CALL NO. 100  
CONTRACT ID NO. 201015  
ADDENDUM # 1

Subject: LIVINGSTON COUNTY, STP BRO 0601 (196)  
Letting March 20, 2020

- (1) Revised - Special Note for Instrumentation on Existing Bridge -  
Pages 99-108 of 318
- (2) Revised - Special Note for Mitigation of Impacts to the Cumberland River -  
Page 151 of 318
- (3) Revised - Special Note for Steel Erection - Pages 156-163(a) of 318
- (4) Added - Special Note for Ahead Station Embankment Construction -  
Page 175(a)-175(b) of 318
- (5) Added - Special Note for Engineering-Related Consulting Services -  
Page 175(c) of 318
- (6) Revised - Proposal Bid Items - Pages 313-318 of 318
- (7) Revised - Plan Sheets - Pages S26, S30, S35, S55, S87, S97, S98, S99,  
S100, U3, U5, U12, U13, and U15

### Livingston County – US 60 Bridge over the Cumberland River Item No. 1-1142.0

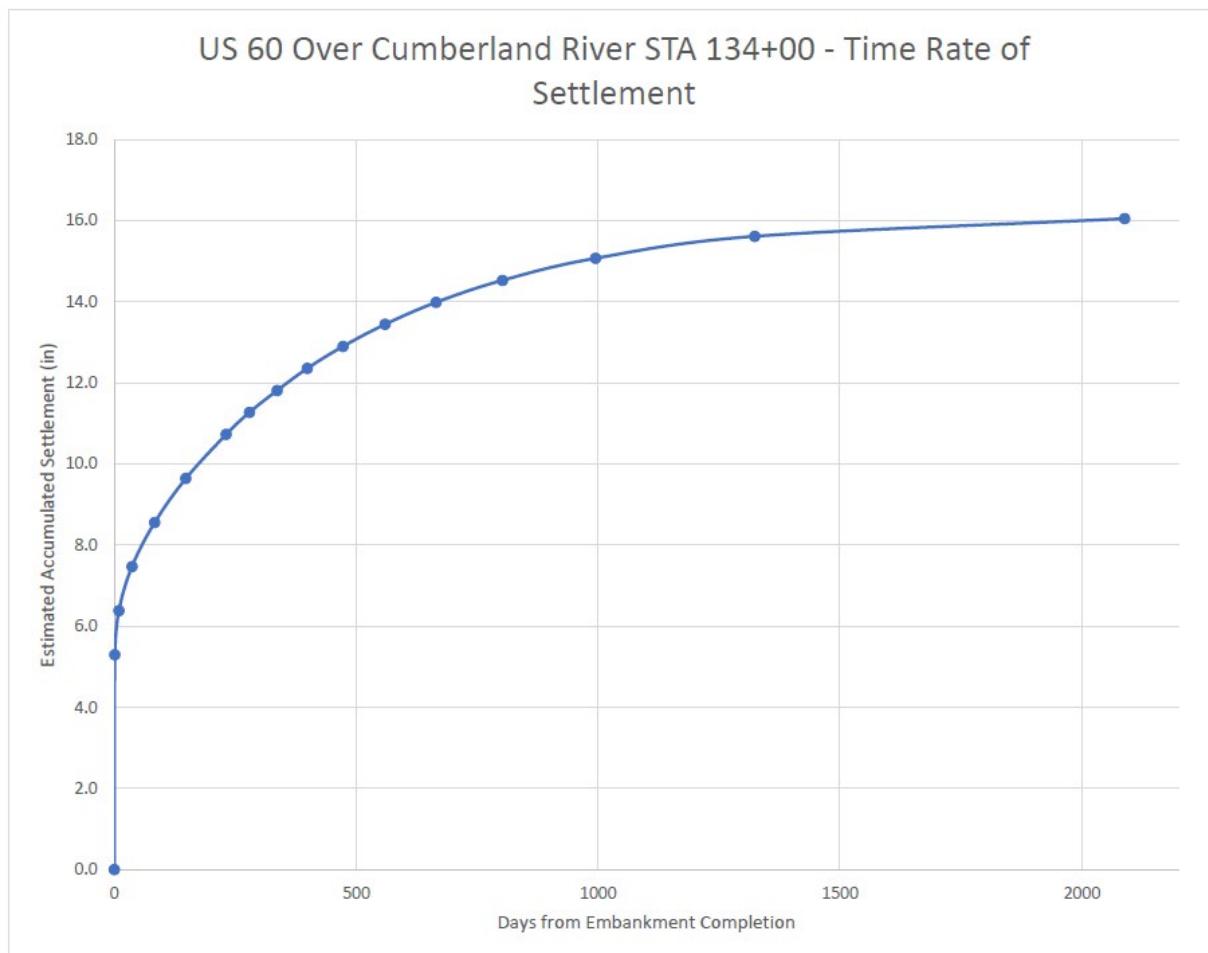
Settlement analysis performed at Station 134+00 predicted approximately 16 inches of settlement with approximately 90% of the settlement predicted to occur in approximately 1000 days or about 33 months. The plot on page 2 of this Special Note represents a graphical summary of estimated settlement vs. time. It should be noted that this plot does not consider that some settlement will occur during embankment construction. Because of the estimated settlement magnitude and time, construct the ahead station embankment (Stations 133+50 to 142+00) as one of the first construction operations on the project. Complete embankment construction in this station interval (in accordance with the project roadway drawings and Division 200 of the Standard Specifications for Road and Bridge Construction) to final subgrade elevation by no later than December 31, 2020. Failure to meet this date may result in liquidated damages as defined in the Special Note for Completion Date if such failure is the controlling event that results in not meeting the specified completion date.

The referenced plot is only an estimate and the actual field results are likely to vary. Therefore, furnish and install a settlement platform at Sta. 134+50, 25 ft. left of centerline, prior to the placement of the embankment fill from Station 133+50 to 142+00. Install the settlement platform in accordance with Section 216 of Standard Specifications for Road and Bridge Construction, current edition, and Standard Drawing RGX-015. Replace any settlement monitoring equipment destroyed or damaged by the Contractor at no additional cost to the Department.

PREPARED BY  
**Stantec**  
SHEET NO.  
S87  
DRAWING NO.  
27458

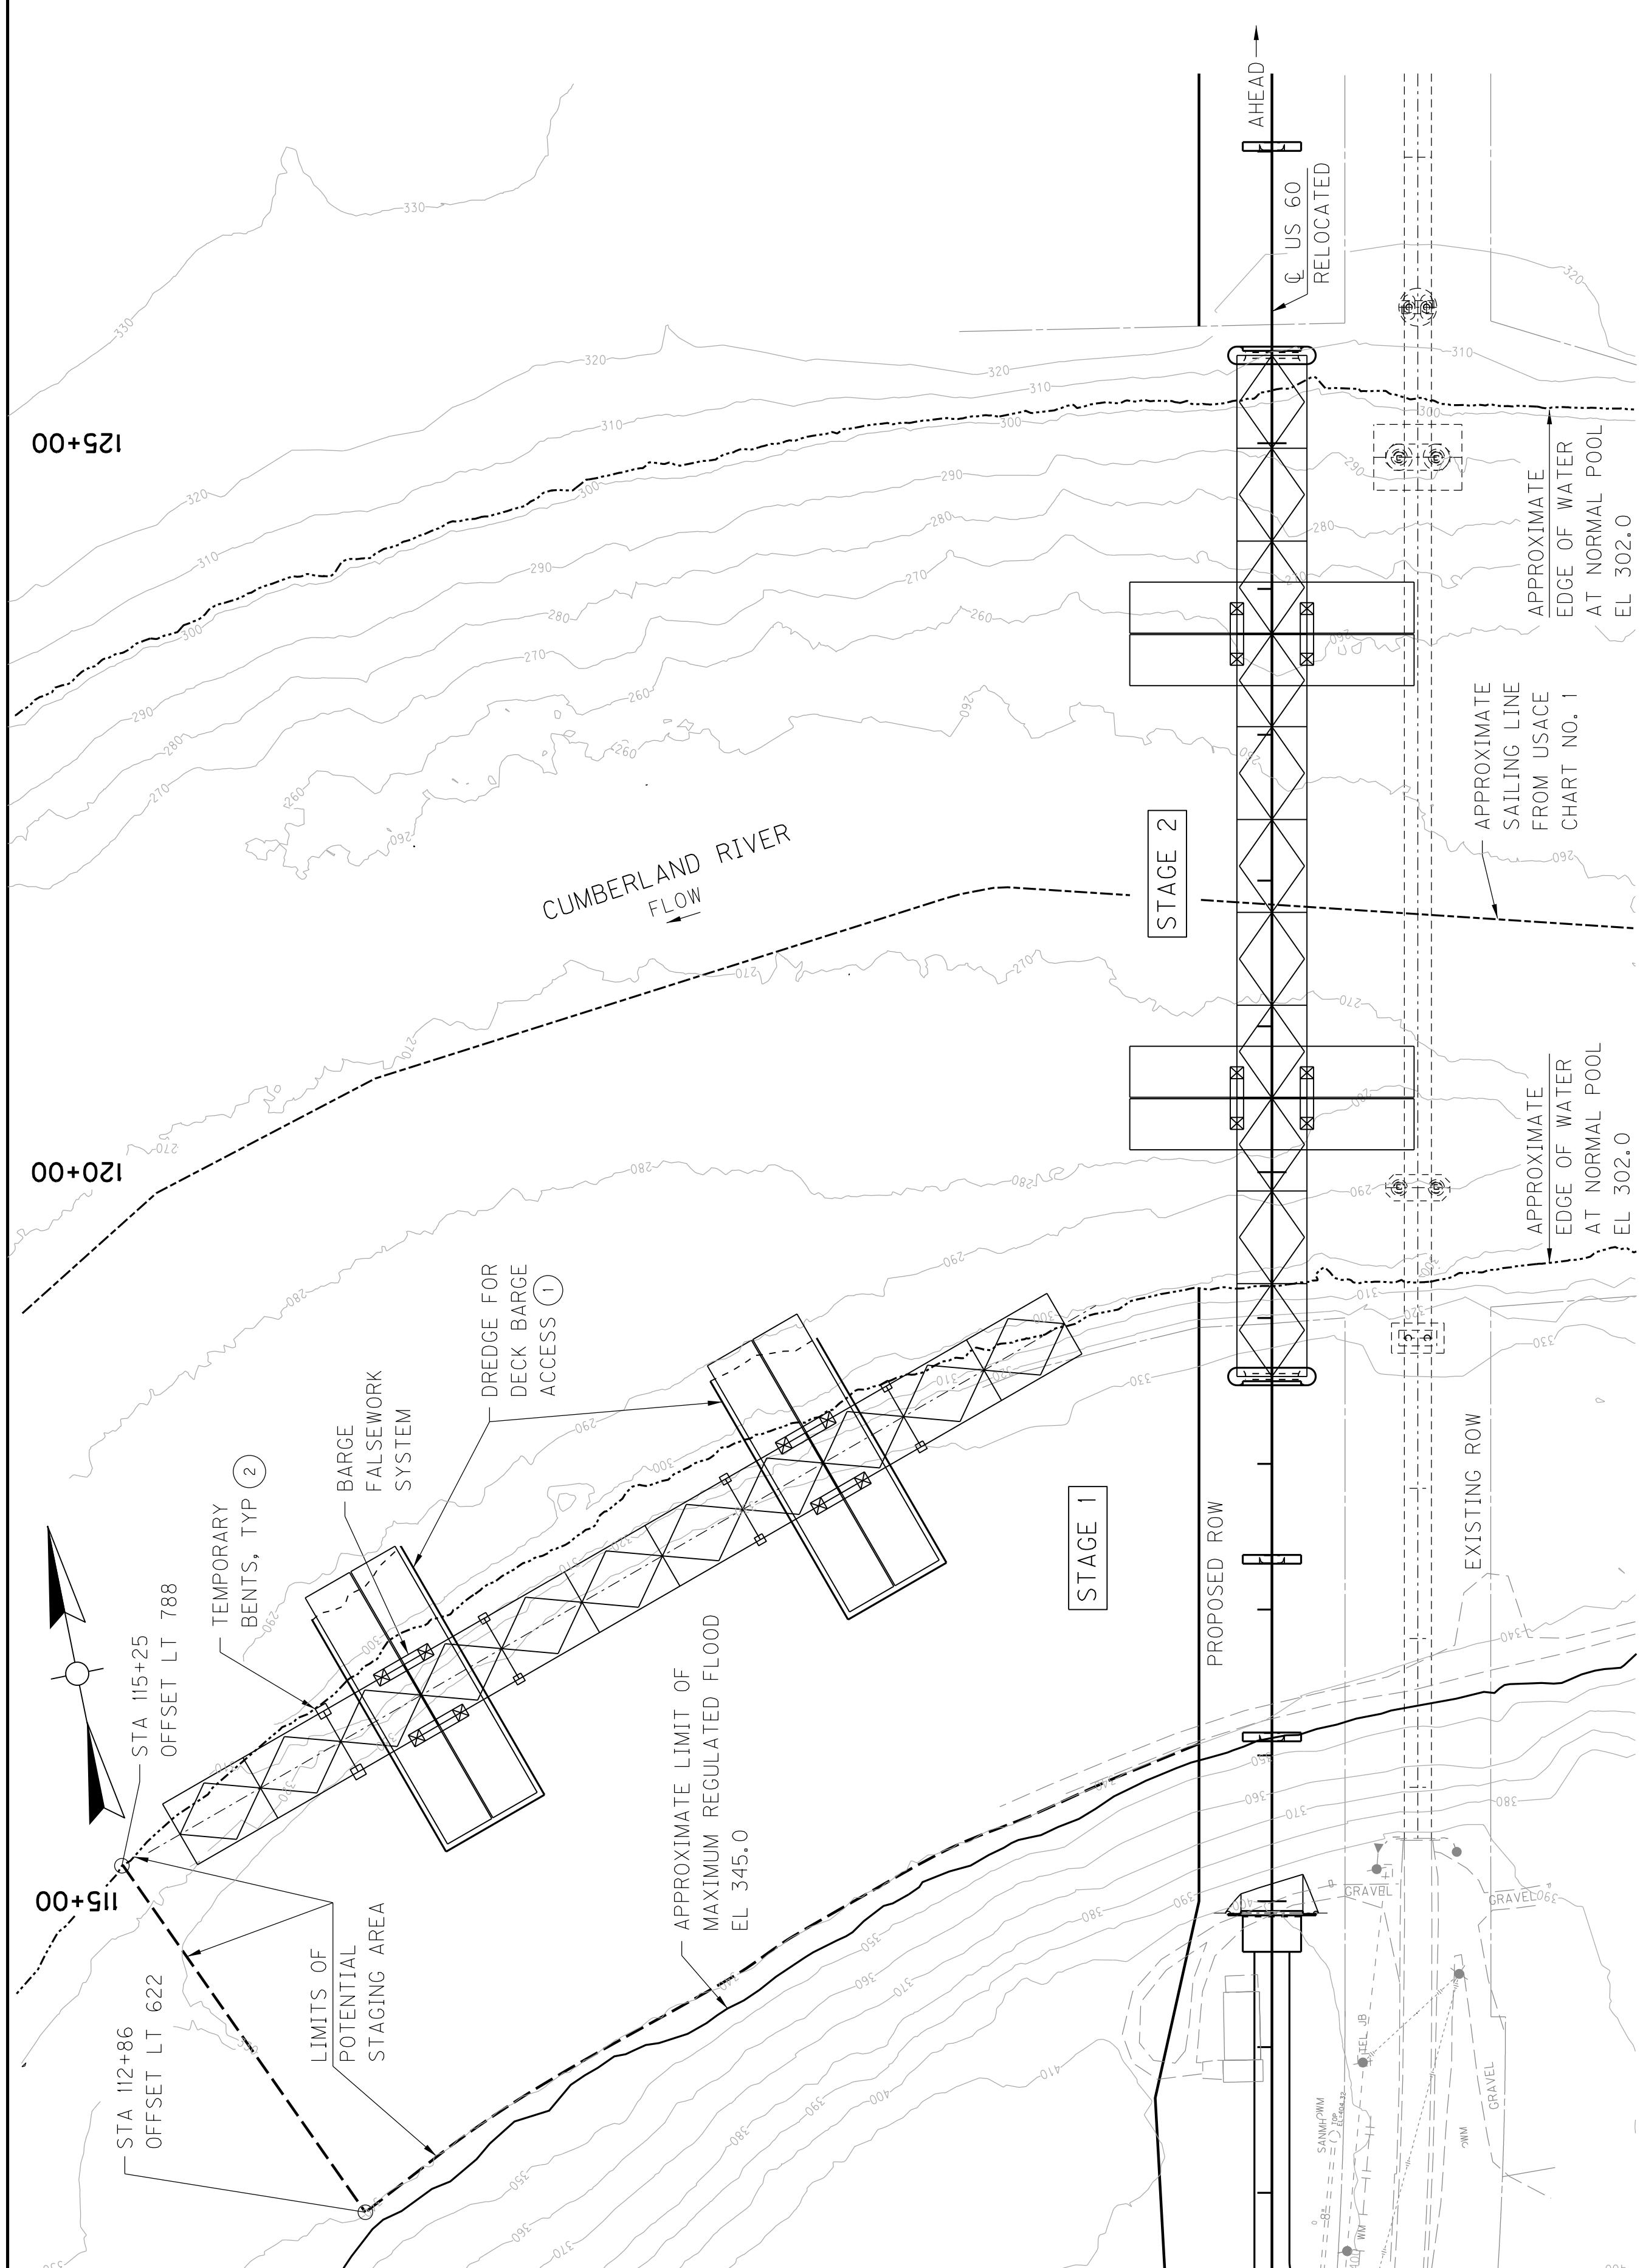
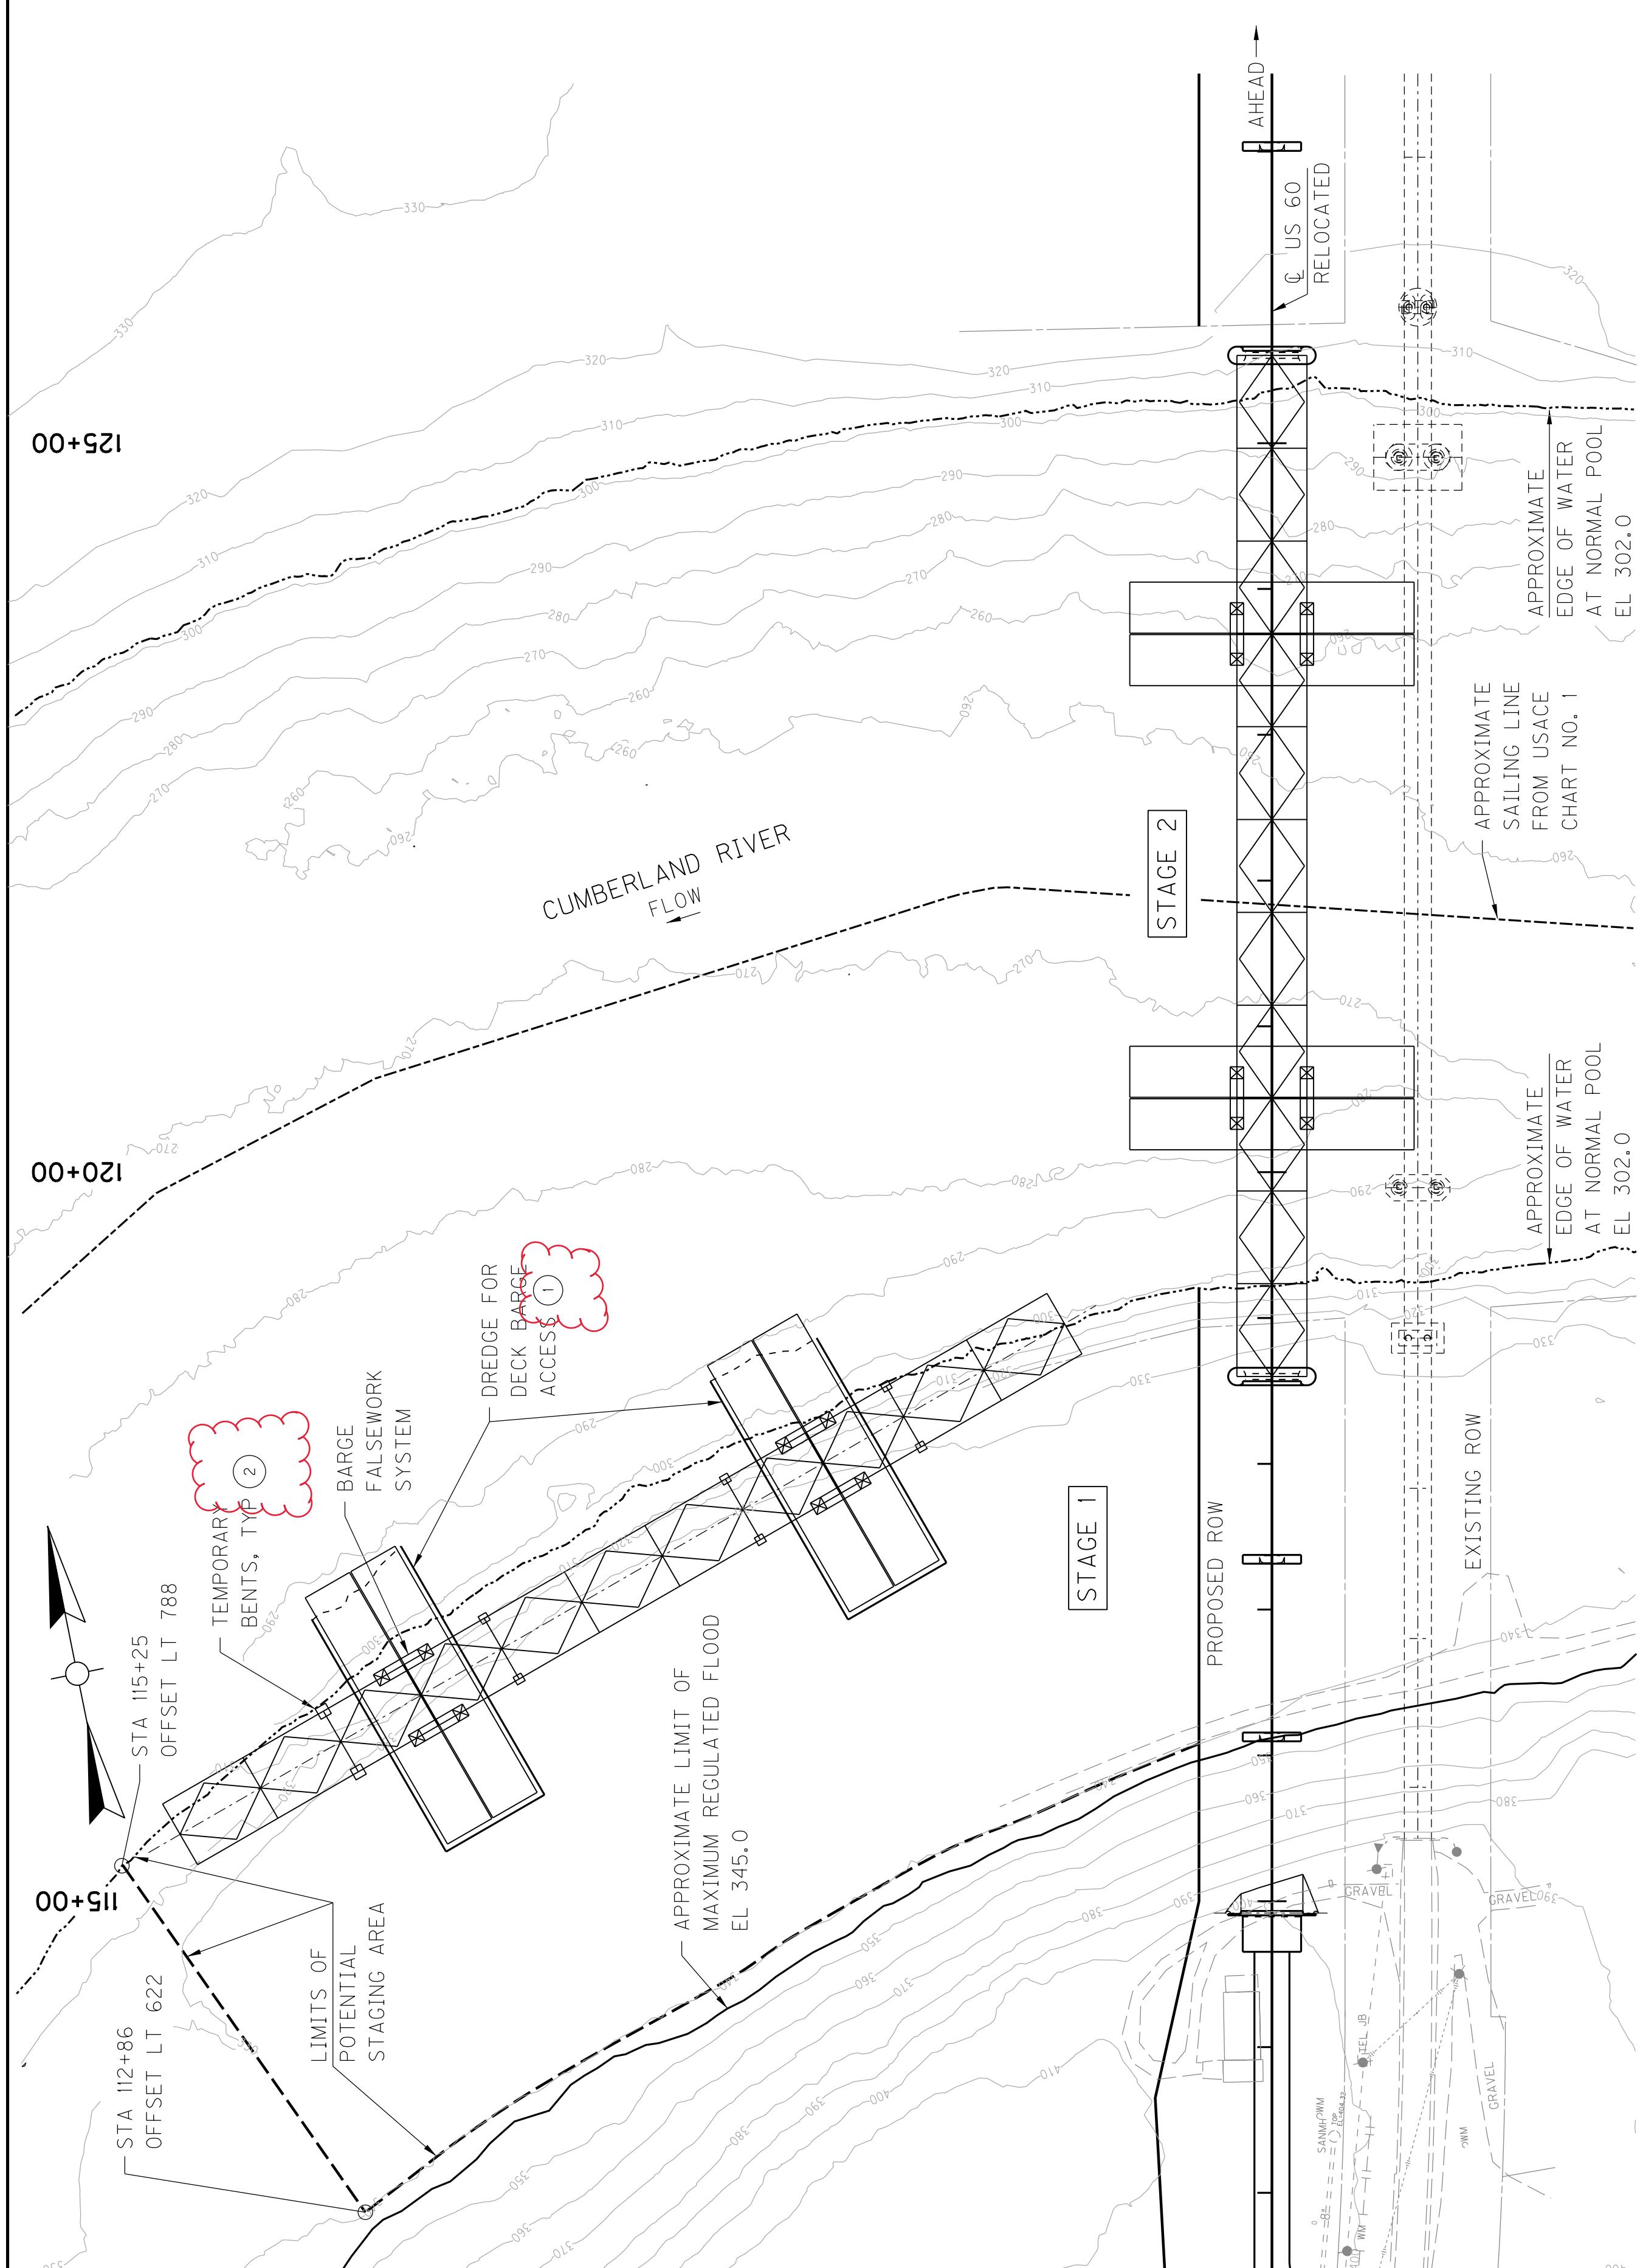
Beyond the limits of acquired Right-of-Way, the Cabinet has completed environmental clearance activities on a construction staging/erection area. This area, defined as *Potential Staging Area* in the Construction Plans (Sheet S87) along the southern bank of the Cumberland River immediately west of the bridge, is available for the Contractor's use without additional environmental clearance activities required. The Contractor should note that the Cabinet has not acquired an easement for

As noted on Sheet S87 and the SPECIAL NOTE FOR MITIGATION OF IMPACTS TO THE CUMBERLAND RIVER IN ACCORDANCE WITH THE BIOLOGICAL OPINION CONCERNING FAT POCKETBOOK MUSSELS, all work associated with meeting environmental commitments for any staging area shall be included in the lump sum unit price for Structural Steel. This includes backfilling excavated/dredged areas, grading backfilled areas to original ground conditions, and providing slope protection of backfilled areas.
